## ORIGINATION FORM

Proposed Revisions to a Standard Plans Index  
(Please provide all information — Incomplete forms will be returned)

Index Number: 455-101

Index Title: Square CFRP & SS Prestressed Concrete Piles -  
Typical Details & Notes +

INDEX  
455-101

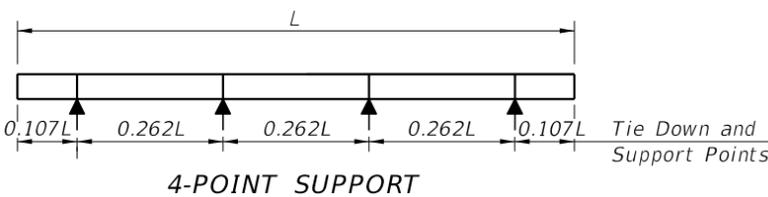
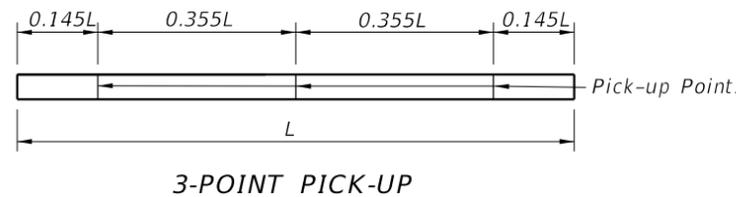
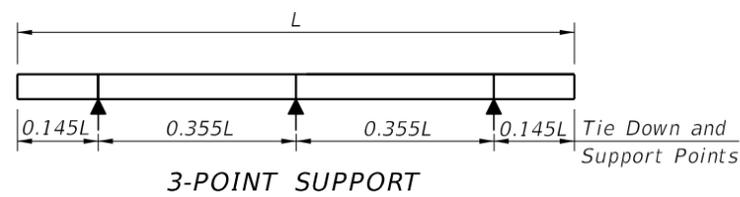
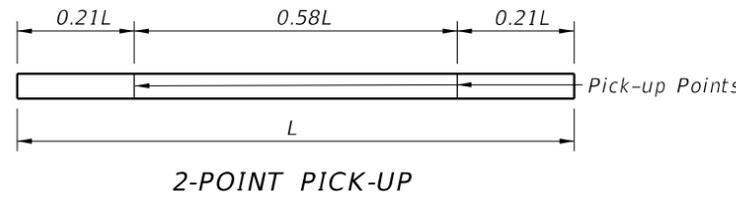
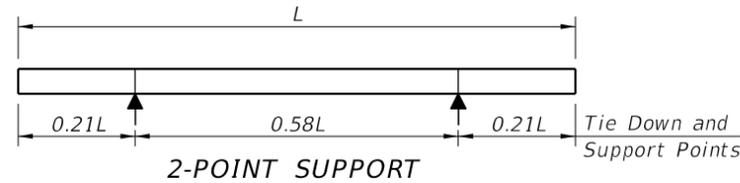
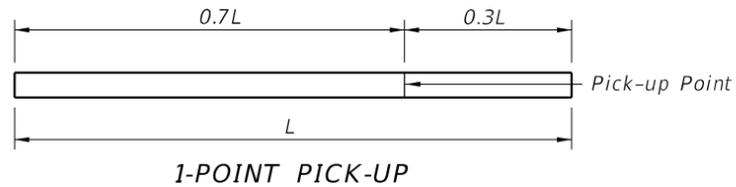
Change Silica Fume, metakaolin or ultra-fine flyash to Highly Reactive Pozzolans ; Changed Note 4B

Specification changed to fit silica fume, metakaolin and ultra-fine flyash under Highly Reactive Pozzolans. SS strand now covered by specification so only need Grade called out.

2. Concrete:
  - A. Piles: Class V (Special)
  - B. Silica Fume: See "GENERAL NOTES" in the Structures Plans for locations where the use of silica fume, metakaolin or ultra-fine flyash is required for options using stainless steel strand and reinforcing.

- b. Carbon FRP: Meet the requirements of Specification Section 932.
  - B. Prestressing Strands:
    - a. Stainless Steel: Seven-wire HSSS, ~~UNS S32205 (Type 2205) or UNS S31803~~ **Grade 240** strand, meeting the requirements of Specification Section 933.

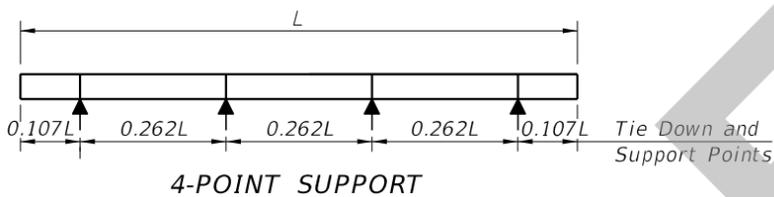
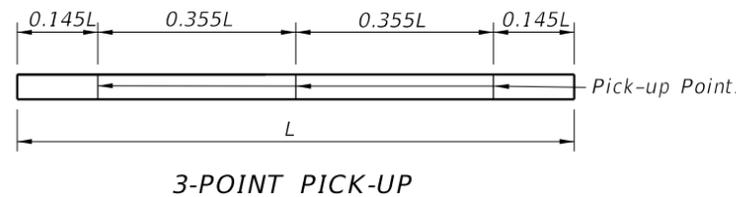
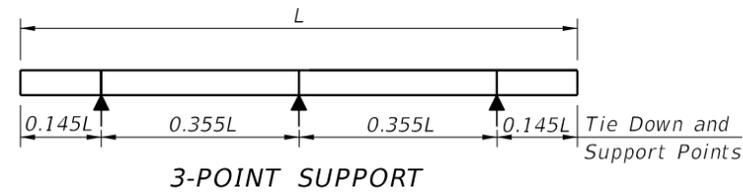
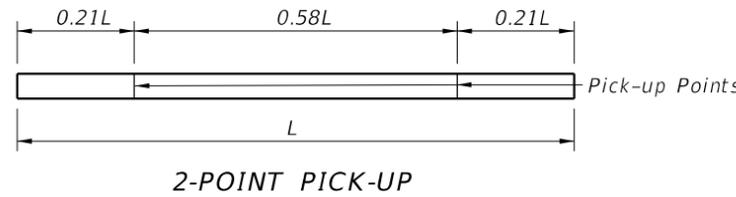
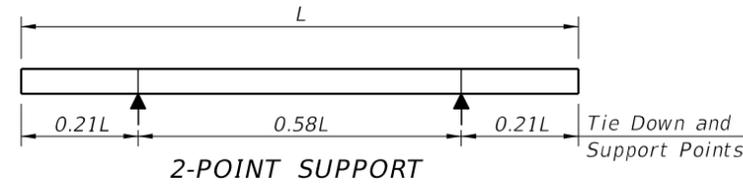
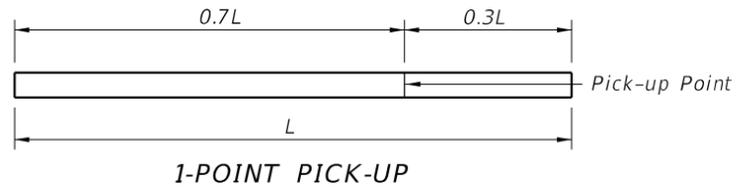
2. Concrete:
  - A. Piles: Class V (Special)
  - B. See "GENERAL NOTES" in the Structures Plans for locations where the use of Highly Reactive Pozzolans is required for options using stainless steel strand and reinforcing.
